Upper Brook Street, Masterplan
(Williams Motor Co (Holdings) / Alliance
UBS Limited)

Planning Ref: 137401/FO/2023

**Improvements to Junction of
Upper Brook Street / Booth
Street East / Inchley Road**

**Highways Technical
Note 05**

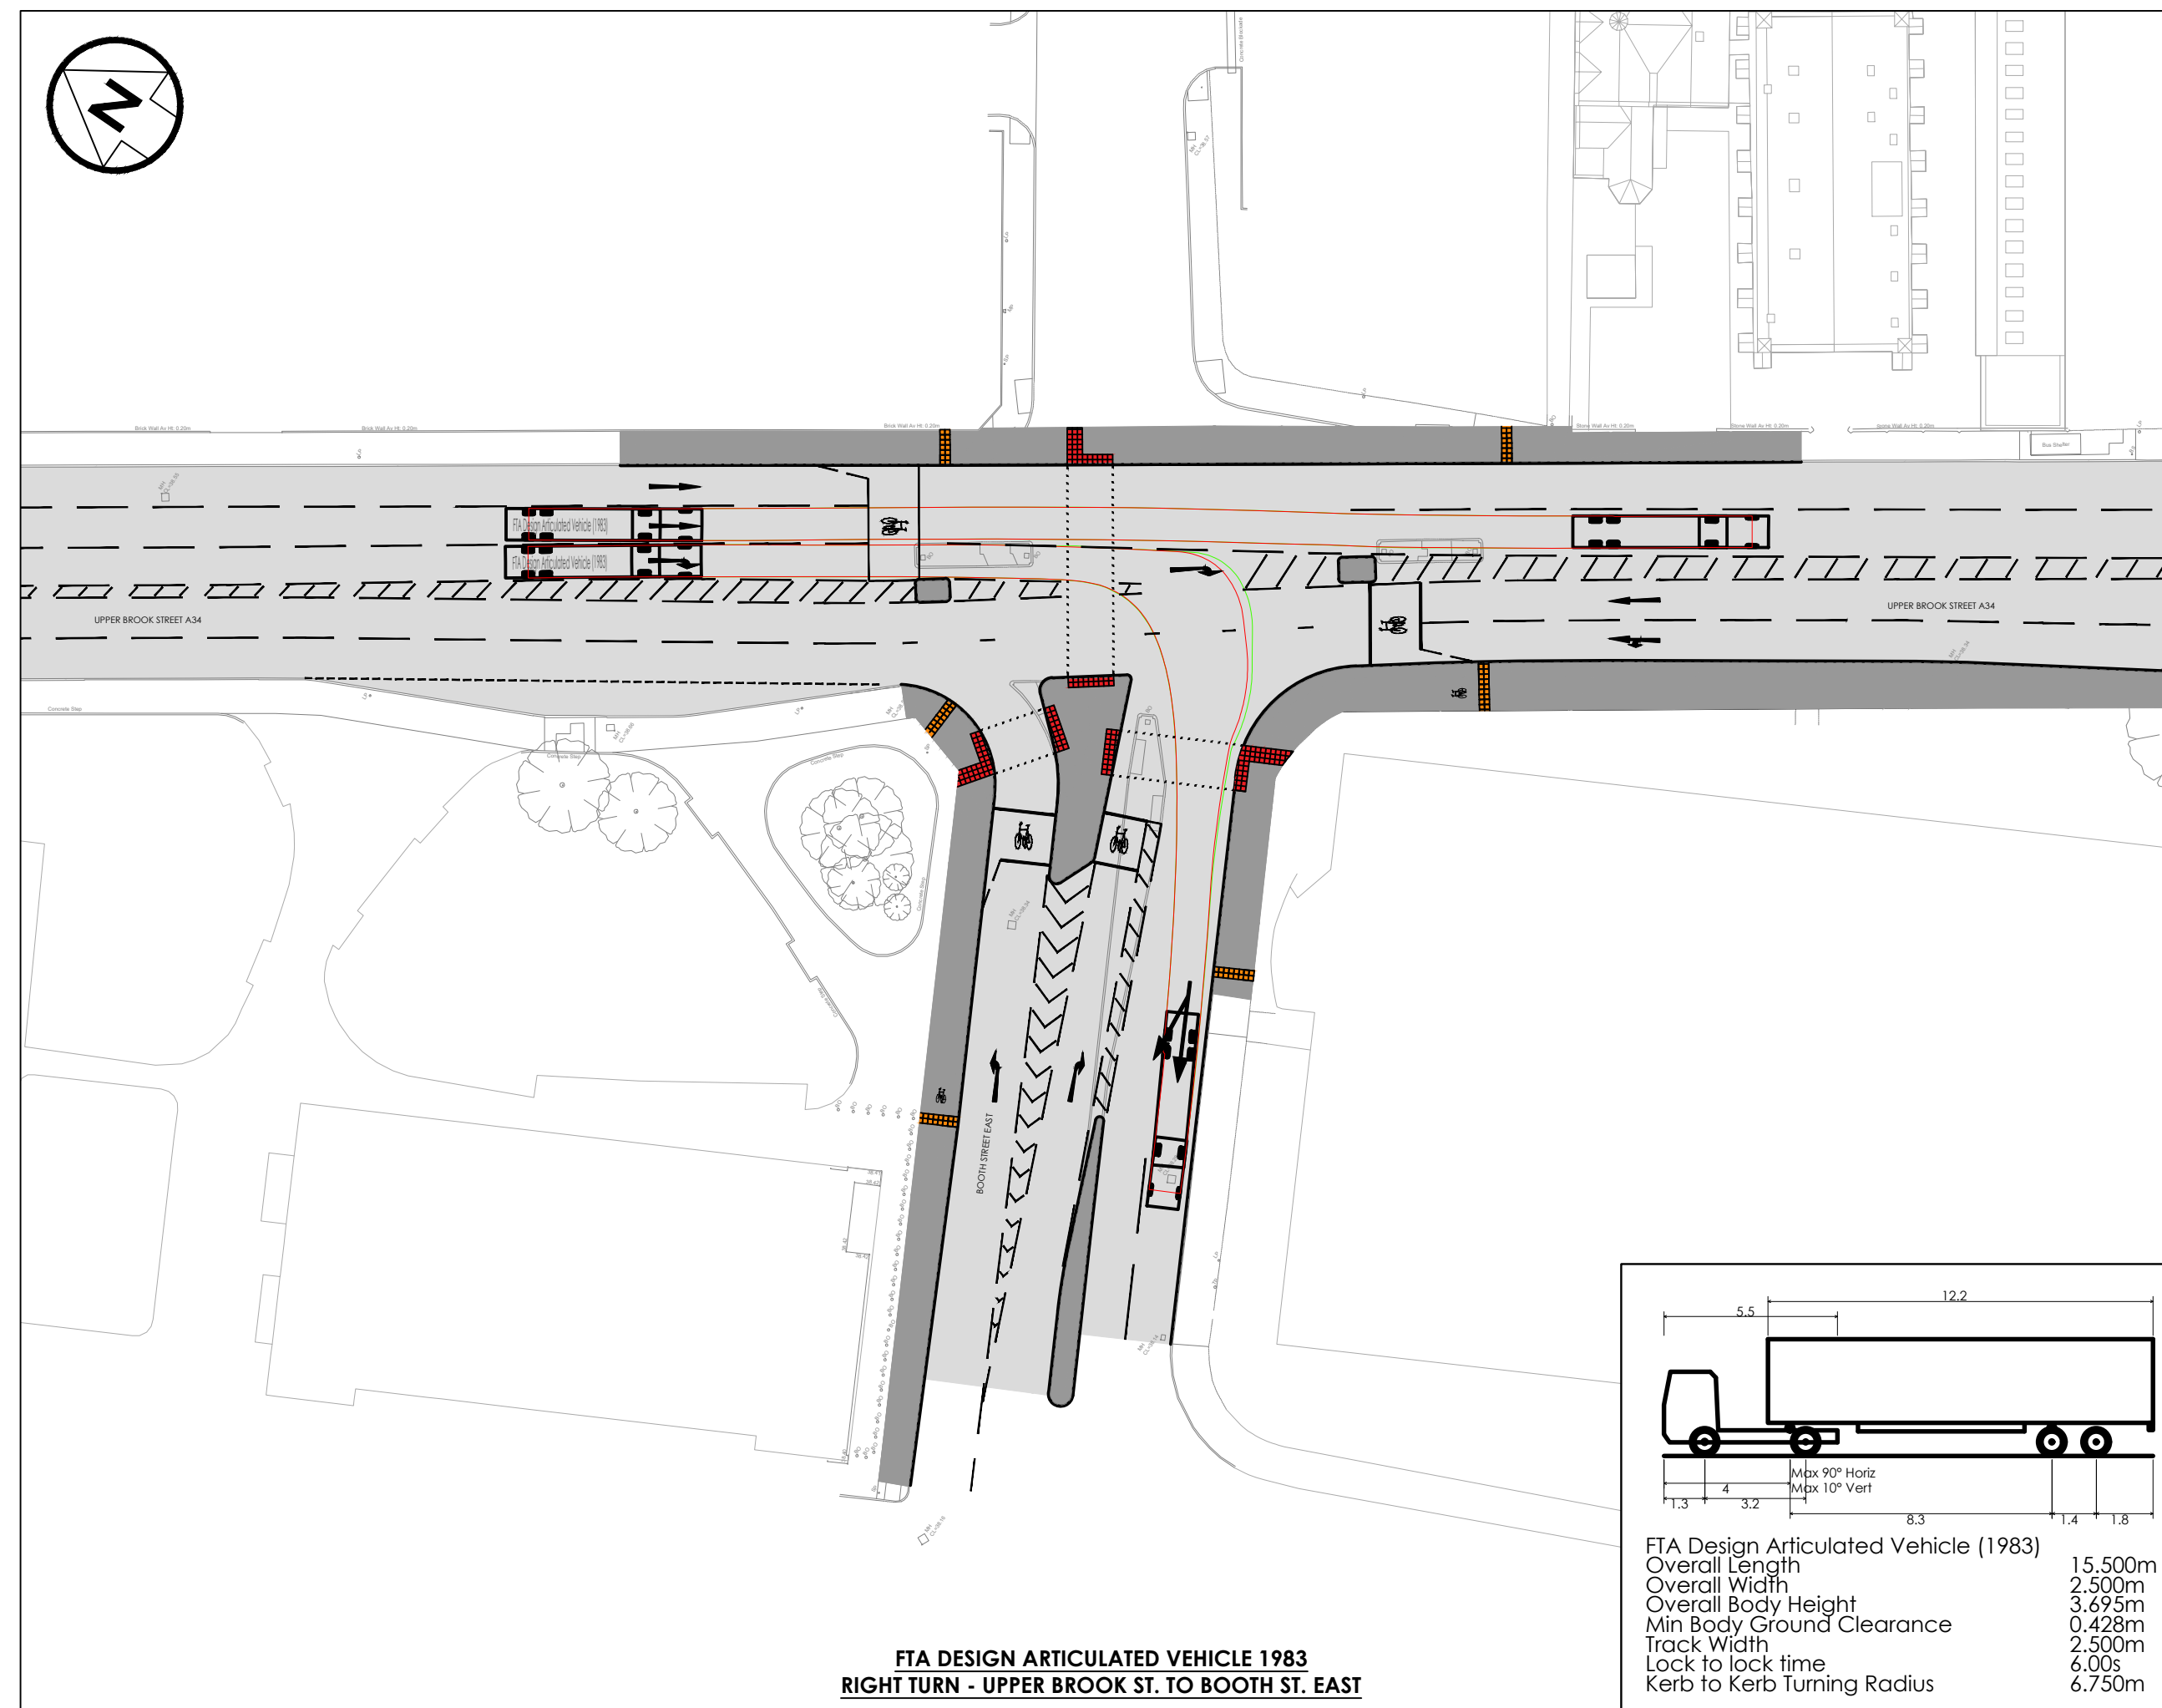
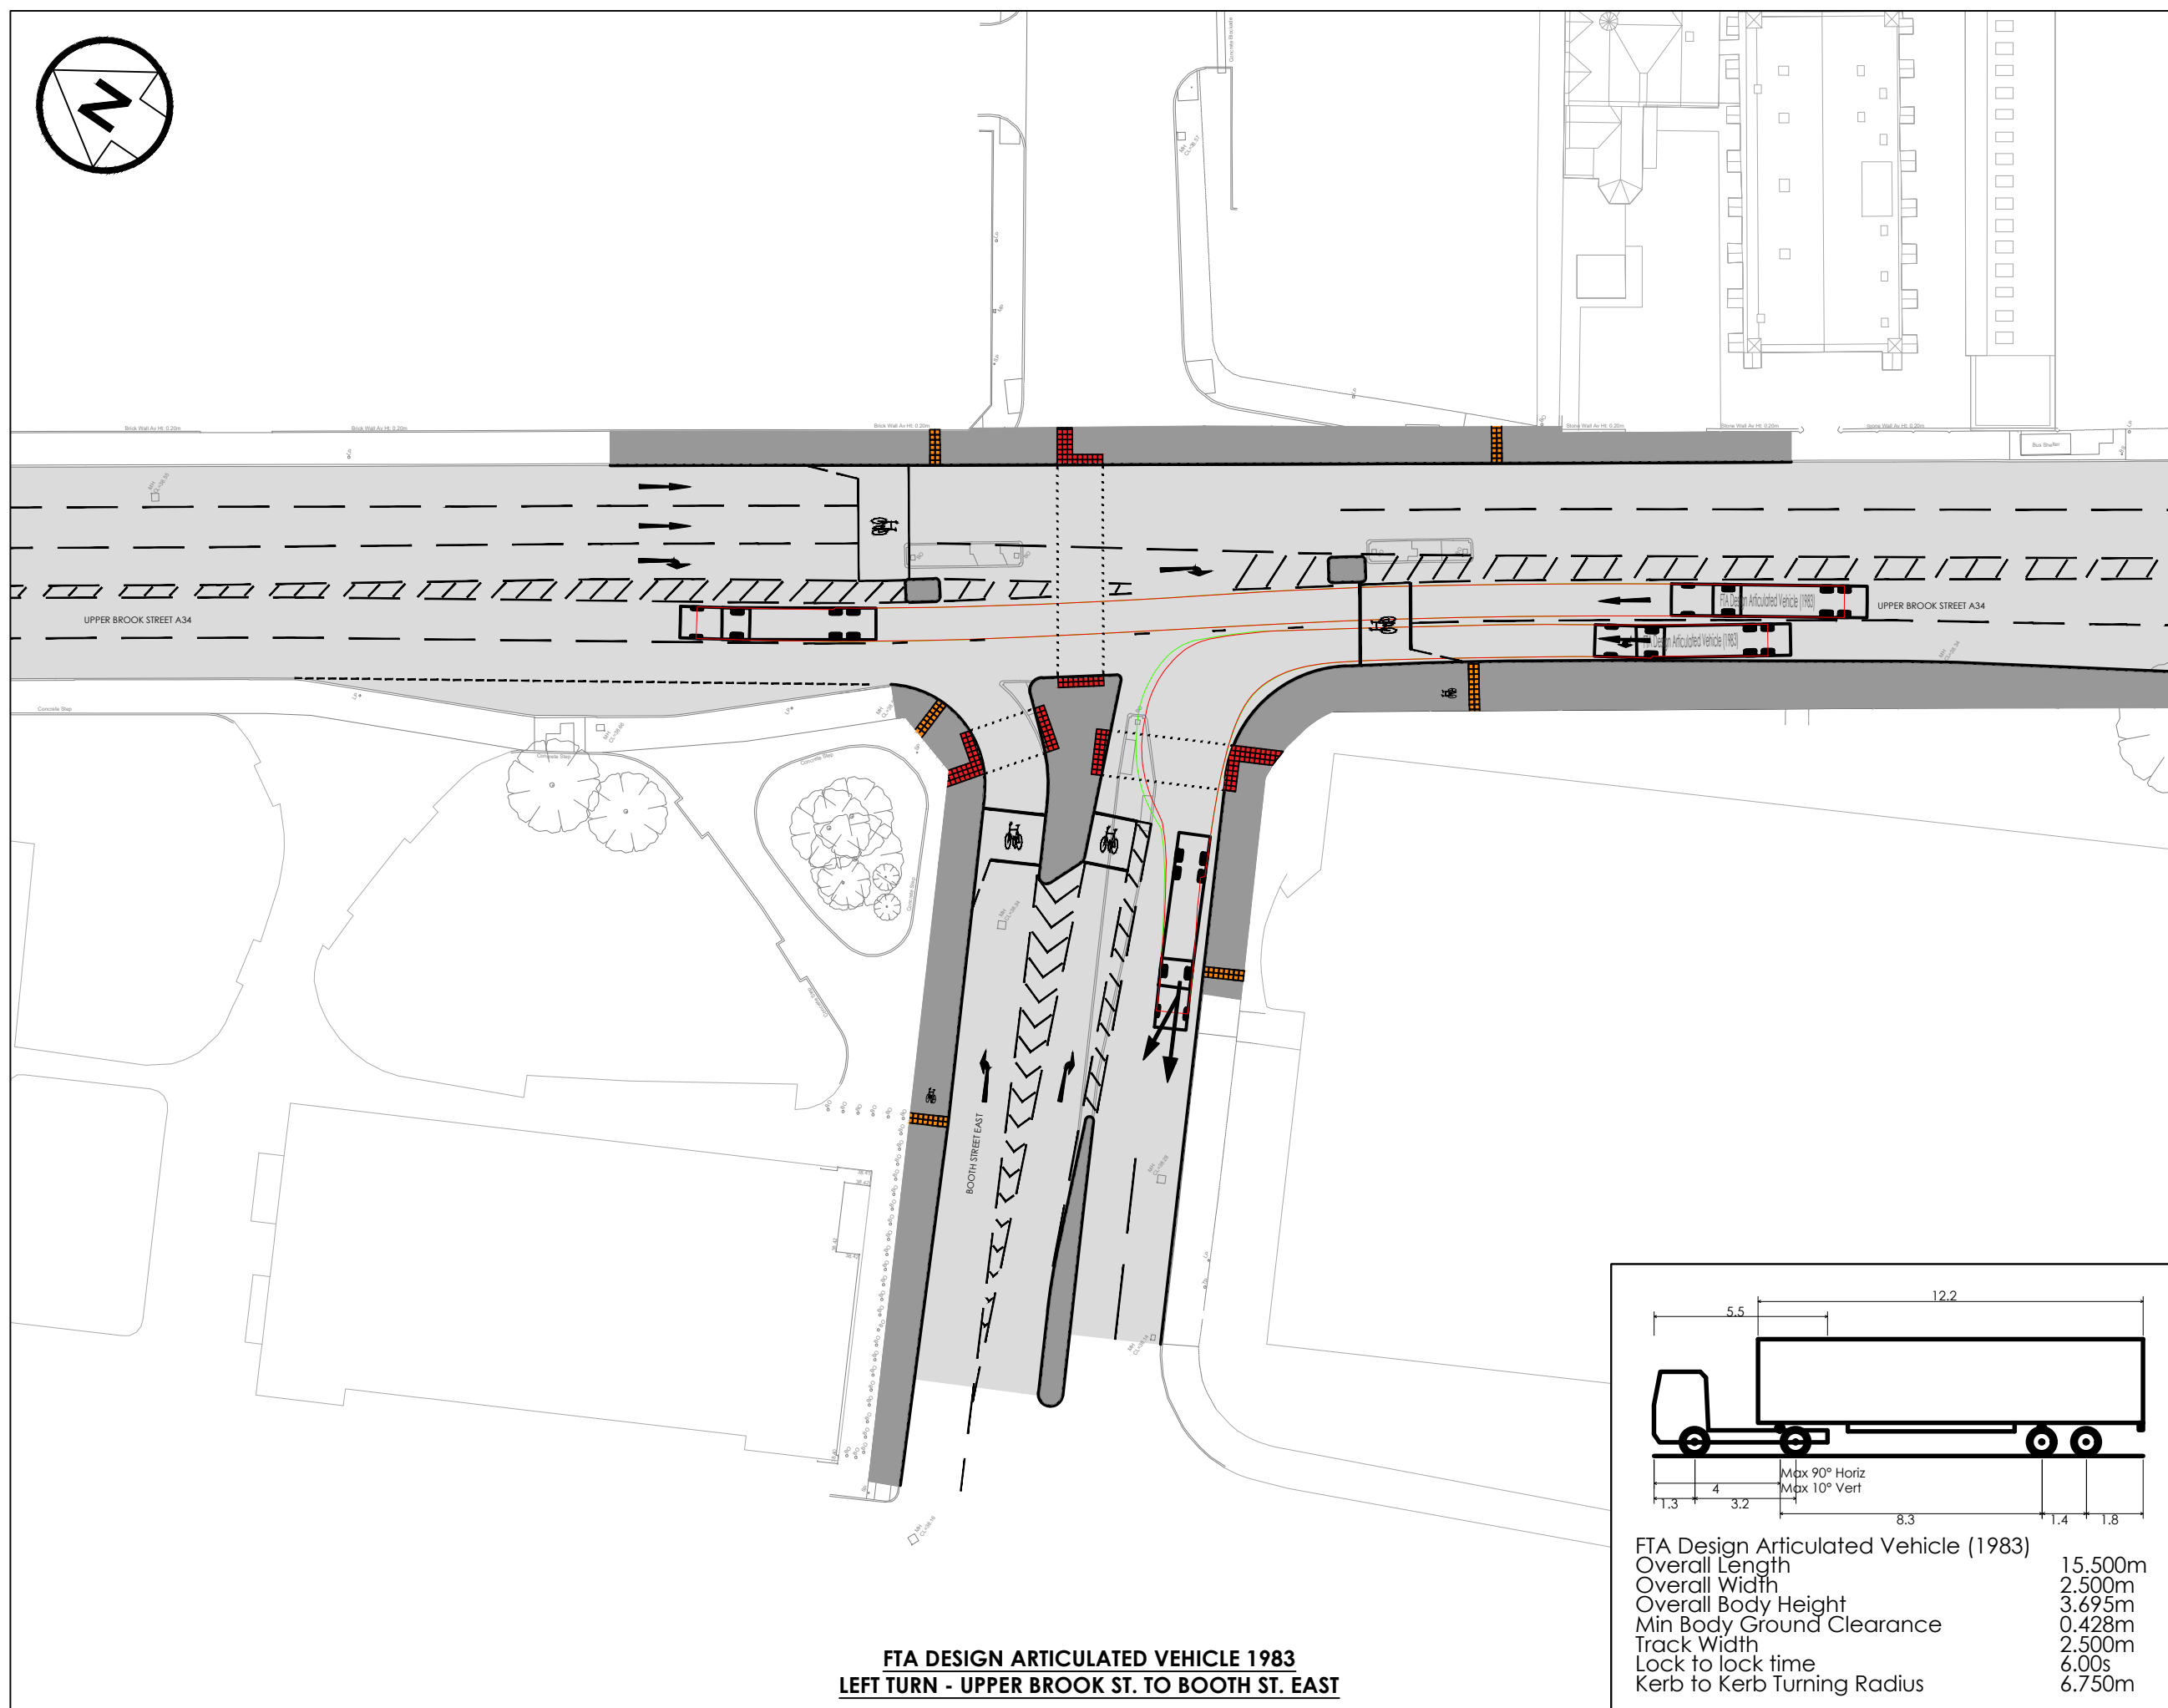
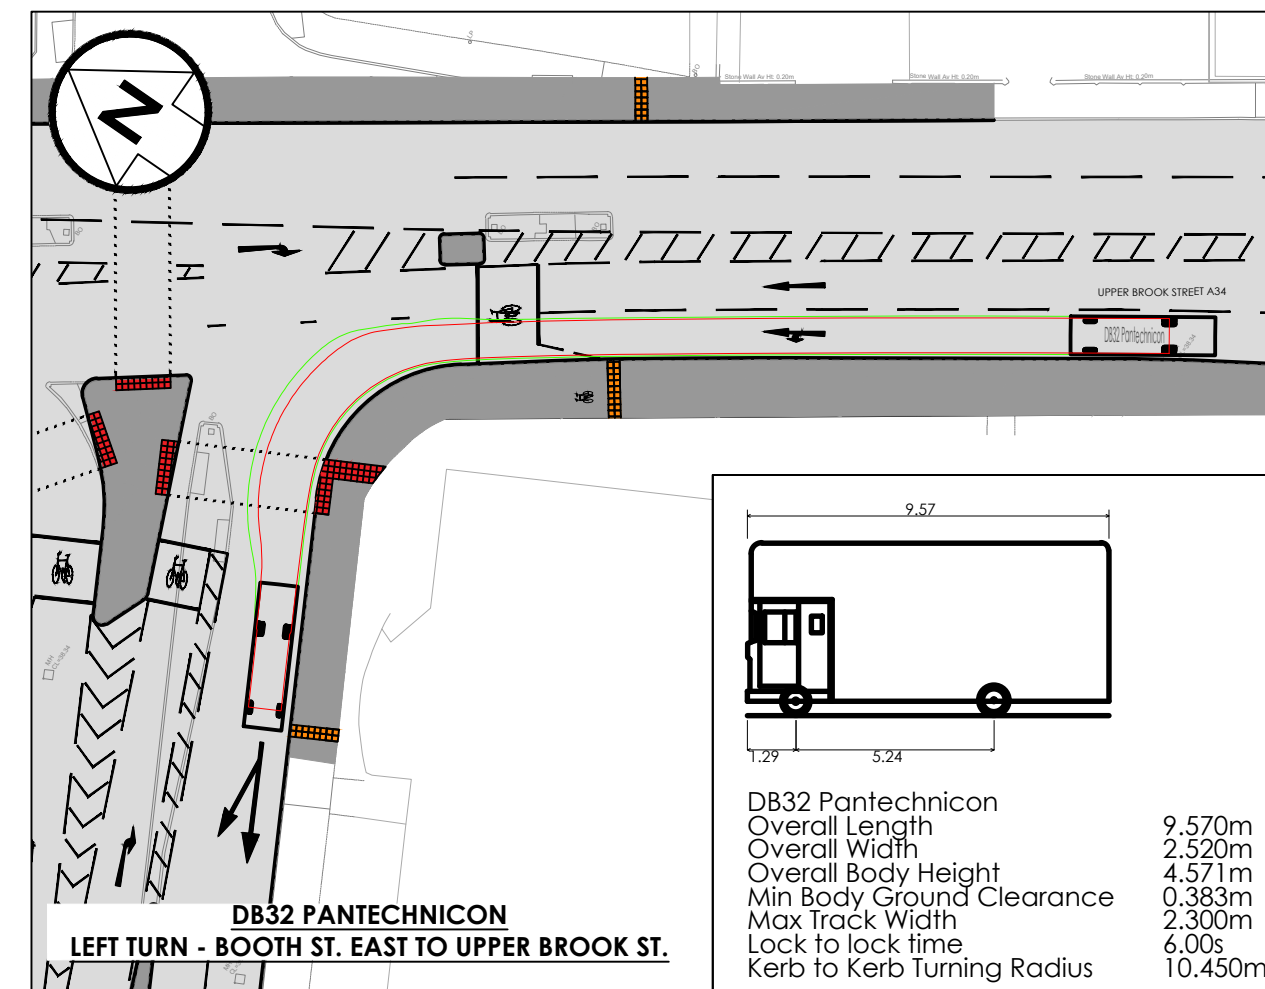
RSA problem		RSA recommendation	Design organisation response	Overseeing Organisation response	Agreed RSA action
3.1.1	<u>LOCATION:</u> Booth Street East <u>SUMMARY:</u> Alignment could result in conflicts It is proposed to realign the approach arrangement to the junction whereby forming a large splitter island between the left and right turns but omitting the existing offside splitter island which currently segregates north and southbound traffic. Concern is expressed that the proposed alignment is unusual in its formation whereby traffic turning right out of Booth Street East have a nearside island but nothing to protect on the offside from traffic turning into the side road as is the current situation. Not only is there a risk of driver confusion as to the proposed road layout, such an arrangement increases the risk of head-on type conflicts between traffic turning right out of the side road and traffic turning into it	An alternative layout should be investigated, for example repositioning the splitter island to the offside of the right turn lane and keeping the left and right turn traffic lanes together.	Response: Partially Accepted Given available highway constraints to the junction it is not possible to incorporate an additional splitter island on Booth Street East of sufficient size to safely accommodate an active travel user (ATU) refuge. A range of junction options were considered at a stakeholder design workshop session and the principles of the current arrangement were identified as providing the best opportunity to deliver enhanced ATU crossing facilities within junction land constraints. The layout of adjacent opposing traffic streams at a side road approach to a junction is similar in nature to other recently delivered schemes elsewhere within the city centre as part of ATU related improvement works. Variations considered at the workshop stage did include for the potential to reduce the size of the central splitter in order to reduce the extent of 'deflection' around the island for approaching traffic and potentially allow for the provision of a narrow traffic signal island (at circa 1.8m) between the opposing traffic streams. Such an option was ultimately rejected on the grounds that:	MCC/TfGM Response

3.1.2	<u>LOCATION</u>: A34 northbound through the junction <u>SUMMARY</u>: Through alignments could result in conflicts The northbound through alignment is	The alignments should be adjusted as not to cause conflict between lane 1 and lane 2.	Response: Accepted The comments from the audit team are accepted. The design team have reviewed the layout of the Upper Brook Street northbound approach and have revised the alignment through	MCC/TfGM Response

3.1.3	<u>LOCATION:</u> A34 northbound <u>SUMMARY:</u> Insufficient capacity could result in conflicts It is unclear as to whether removing one of the existing 3 northbound through lanes will significantly affect junction or link capacity causing congestion and increasing the potential for sudden braking or weaving type conflicts throughout	A review of the traffic model should be undertaken to ensure that the junction and link operate within capacity	Response: Accepted The removal of one of the three northbound lanes to UBS is not predicted to result in capacity or congestion issues. In practice, the part of the approach section of Upper Brook Street to the south of the junction already operates as a two-lane approach and only widens to three lanes approximately 130m to the south. Removal of this additional lane will therefore not result in additional weaving issues as there will be no requirement to change lanes as a result of the new arrangements.	MCC/TfGM Response

3.1.4	<u>LOCATION:</u> A34 approaches <u>SUMMARY:</u> Insufficient through lane widths 3m-3.2m wide traffic lanes have	Through traffic lane widths should be suitably increased.	Response: Rejected The proposed lane widths to Upper Brook Street are based on the lane dimensions currently in day-to-day use at the junction.	MCC/TfGM Response

the following amendments (see 766-042-WCL-009 - 012 (P03) General Arrangement (Option 3)): - Slight narrowing and re-shaping of the central splitter island to reduce perceived extent of deflection for the right turn lane around the island and to better align this lane in relation to the entry lane from Upper Brook Street. - Introduction of additional road markings to deliver an area of hatched segregation between the two lanes and to guide turning traffic into Booth Street East to follow a suitable alignment. Vehicle swept path testing of the layout as illustrated in drawing 766-042-WCL-024 (P02) demonstrates that all vehicle turning movements can be wholly accommodated within the amended marked Booth Street East entry lane with the articulated lorry showing the worst case swept path. In practice the Nov 2022 traffic surveys identified that large HGV traffic (OGV2) represented only 0.3% of all left turn traffic movements from Upper Brook Street to Booth Street East for the core daytime 12hr period (07:00-19:00).

such that lane 1 traffic is deflected to the offside due to the cycle facility widening and a similar point, lane 2 traffic is deflected to the nearside to accommodate the opposing right turn pocket. This arrangement could increase the potential for side swipe type conflicts between lane 1 and lane 2 traffic within the junction.		the junction as illustrated in drawings (766-042-WCL-009 - 012 (P03) General Arrangement (Option 3)) This amended alignment involves the extension of the proposed section of footway widening to the westbound side of upper Brook Street (S) to provide a longer, straighter 2 * 3.2m lane approach to the junction stopline. This arrangement addresses the identified issue of consecutive nearside and offside lane deflection and therefore reduces the potential for side-swipe incidents. Additional road markings to Diagram 1005 have also been provided along the centre line of the northbound carriageway to guide vehicles across the junction more effectively. Revised swept path assessment illustrating relevant through vehicle & turning movements is included in drawing 766-042-WCL-024 (P02).

been proposed for the through traffic lanes. Given this is a bus route and used by large HGVs, concern is expressed that 3m-3.2m wide traffic lanes are insufficient and could encourage encroachment into the adjacent traffic lanes lane risking conflicts with adjacent vehicles.		The proposed arrangements do not result in any material reduction in road space. Due the surrounding land constraints it is not possible to deliver a practical increase in junction dimensions. By way of demonstration, drawing 766-042-WCL-SK-001 Existing Lane Widths, to this report illustrates existing Upper Brook Street approach lane dimensions. This exercise illustrates the following prevailing road widths: Upper Brook Street (N) Approach: 2 * 3.1m lanes Upper Brook Street (S) Approach: 2 * 3.1m lanes, 1 * 2.85m lane. The proposed junction scheme identifies the following provision: Upper Brook Street (N) Approach: 1 * 3.2m lane, 1 * 3.0m lane, 1 * 2.9m lane Upper Brook Street (S) Approach: 2 * 3.2m lanes. To reflect potential for greater use by bus / HGV traffic, the proposed junction improvement scheme includes for 3.2m lane widths to the nearside lanes to both Upper Brook Street approaches. It is ultimately concluded that the proposed lane width dimensions are realistic and appropriate for the location, based on prevailing conditions.
